Docket No. 50-346
License No. NPF-3
Serial No. 1489
Enclosure

APPLICATION FOR AMENDMENT
TO
FACILITY OPERATING LICENSE NO. NPF-3
FOR
DAVIS-BESSE NUCLEAR POWER STATION
UNIT NO. 1

License Condition 2.C.(3)(t), Startup Feedwater Pump System;
Technical Specification 3/4.7.1.2, Auxiliary Feedwater System; and
Basis 3/4.7.1.2, Auxiliary Feedwater System.

STARTUP FEEDWATER PUMP CONFIGURATION

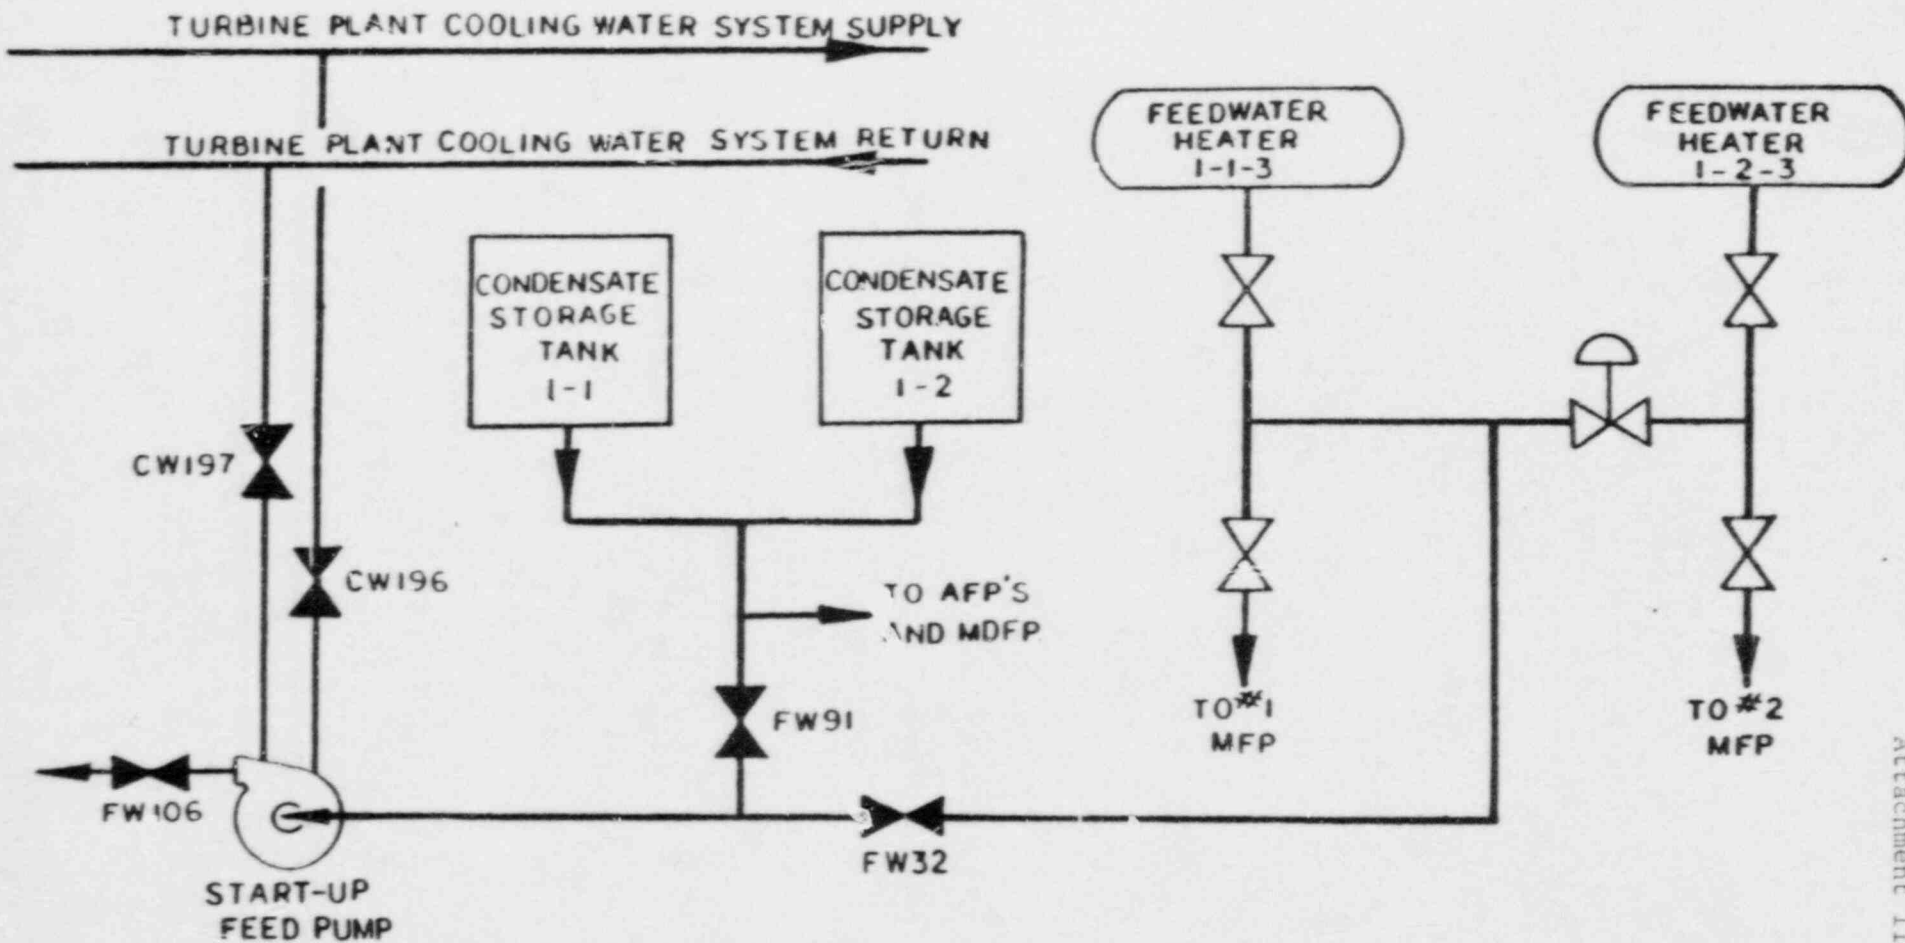
In January 1985, License Condition 2.C.(3)(t) was imposed on the SUFF after it was determined that non-seismic/high energy and moderate energy SUFF/Turbine Plant Cooling Water (TPCW) piping failures could potentially jeopardize operation of the Auxiliary Feedwater Pumps (AFP). License Condition 2.C.(3)(t) (Attachment I) imposed operational restrictions on the SUFF. These restrictions included: 1) stationing an operator in the SUFF/AFP area during SUFF operation; 2) isolating the SUFF and TPCW piping outside the SUFF/AFP area; and 3) installing a new SUFF prior to Cycle 6 operation.

Item 1 of License Condition 2.C.(3)(t) requires Toledo Edison to station an operator in the SUPP/AFP area during operation of the SUPP to monitor the SUPP/TPCW piping in the AFP rooms. In the event of a SUPP/TPCW pipe leakage, the operator will trip the SUPP locally or notify the Control Room to trip the SUPP and isolate the SUPP/TPCW piping.

Item 2 of License Condition 2.C.(3)(t) requires Toledo Edison to isolate and maintain isolation outside the SUPP/AFP area of the SUPP suction, discharge and TPCW piping when the SUPP is not in operation (Modes 1, 2 and 3).

This request proposes deleting License Condition 2.C.(3)(t) and incorporating Item 2 of License Condition 2.C.(3)(t) as Technical Specification Surveillance Requirement 4.7.1.2.a.4. The AFW System Basis is also being revised to reflect this change. Additionally, Toledo Edison proposes clarifying when the provisions of Specification 4.0.4 are not applicable for the AFW Surveillance Requirements.

In conjunction with returning electrical power to the SUPP motor, Toledo Edison proposes to isolate and maintain isolation of the SUPP/AFP area. Isolation will be verified through an additional Technical Specification Surveillance Requirement. Surveillance Requirement 4.7.1.2.a.4 will be added to the AFW System Technical Specification and will require verifying, on a 31-day staggered test basis, for each AFW train, that the TPCW valves (CW196 and CW197), the SUPP suction valves (FW32 and FW91) and the SUPP discharge valve (FW106) are closed (see Attachment II). By maintaining these valves closed, the SUPP/TPCW lines located in the AFP rooms will be isolated, thereby negating the concerns for non-seismic/high energy and moderate energy pipe failures in the AFP rooms when the AFPs are required to be operable. Toledo Edison also proposes to add to the Basis the explanation that by verifying these valves are closed, concerns associated with pipe failures in the AFP rooms are addressed. Toledo Edison therefore proposes deleting Item 2 of License Condition 2.C.(3)(t) and incorporating Technical Specification Surveillance Requirement 4.7.1.2.a.4 in the AFW System Technical Specification.
